SUBMISSION TO DA2019/0391 – 25 LOCH STREET, FRESHWATER

This submission has been prepared on behalf of the owners and occupiers of 23 Loch Street Freshwater, in relation to Development Application DA2019/391 for the demolition of the existing dwelling and construction of a new three storey dwelling on the site at 25 Loch Street, Freshwater. The owners of 23 Loch Street appreciate the consultation that has been undertaken in relation to the proposal, however the design changes requested which have the ability to improve amenity outcomes have not been adopted.

- **Appendix 1 - Images Prepared by 23 Loch Street Architect**

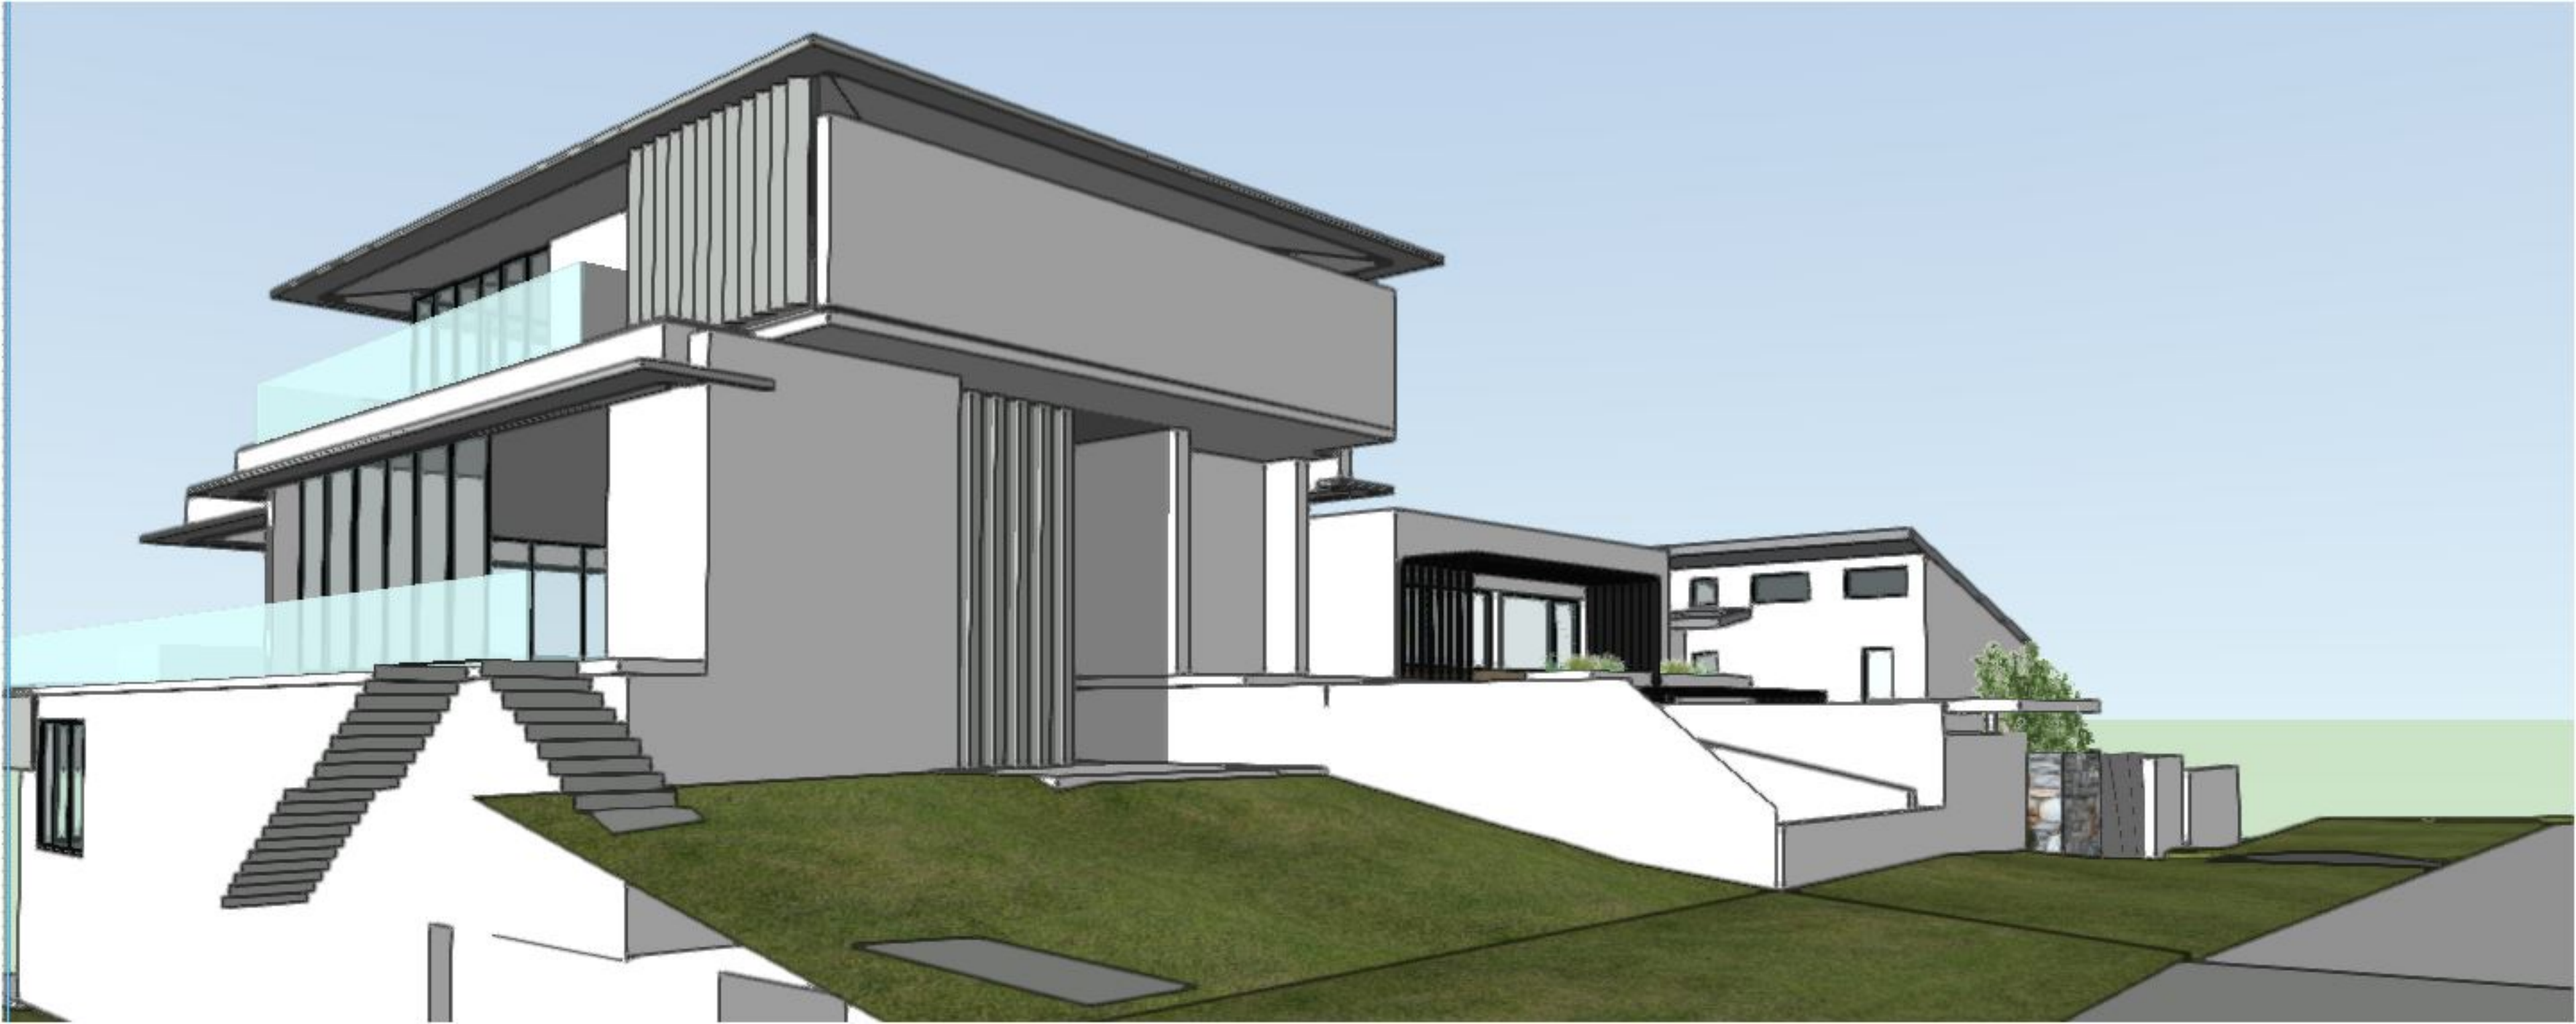
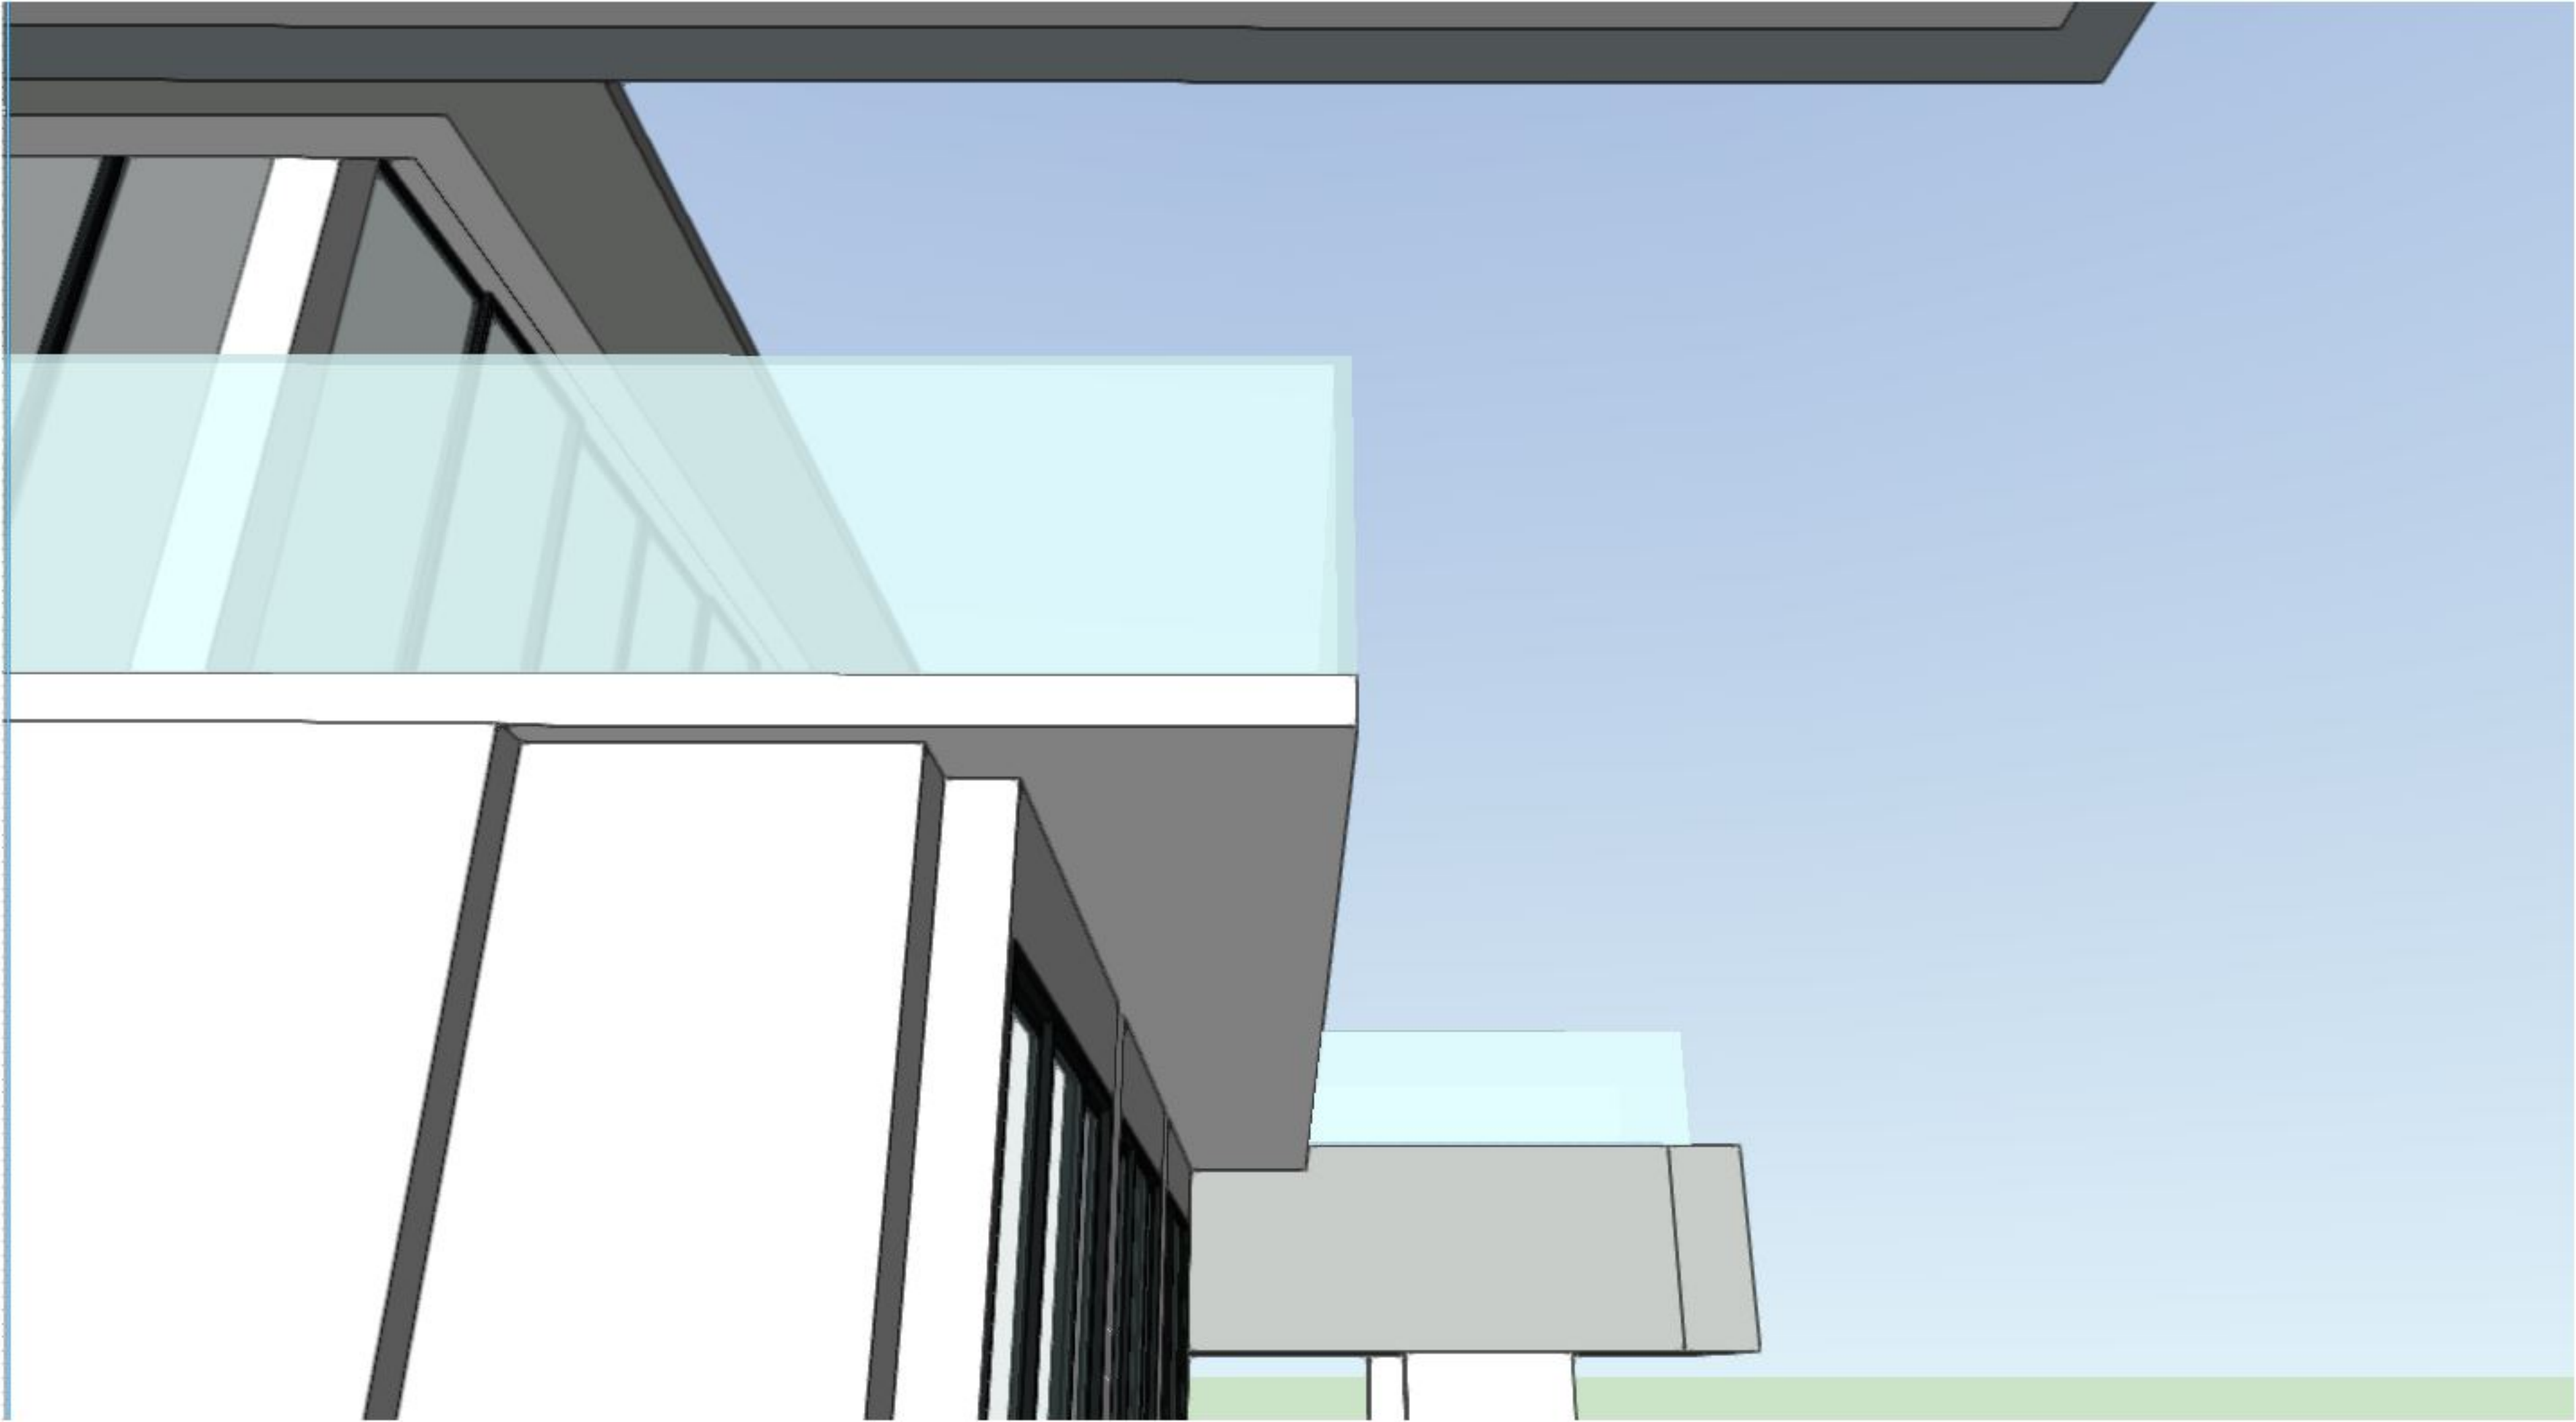
WDCP 2011 (B1) requires that walls are not to exceed 7.2m in height as measured vertically from ground level (existing) to the underside of the ceiling on the uppermost floor of the building. The independent analysis prepared shows that there is a portion of the mid-level and upper floor which does not comply. The proposal should be amended to eliminate this non-compliance as it contributes to the overbearing nature of the development (refer **Appendix 1**).

Images prepared by the Architects for 23 Loch Street show the extent of overlooking that would result and confirm that additional design measures are required to mitigate impacts (refer **Appendix 1**).
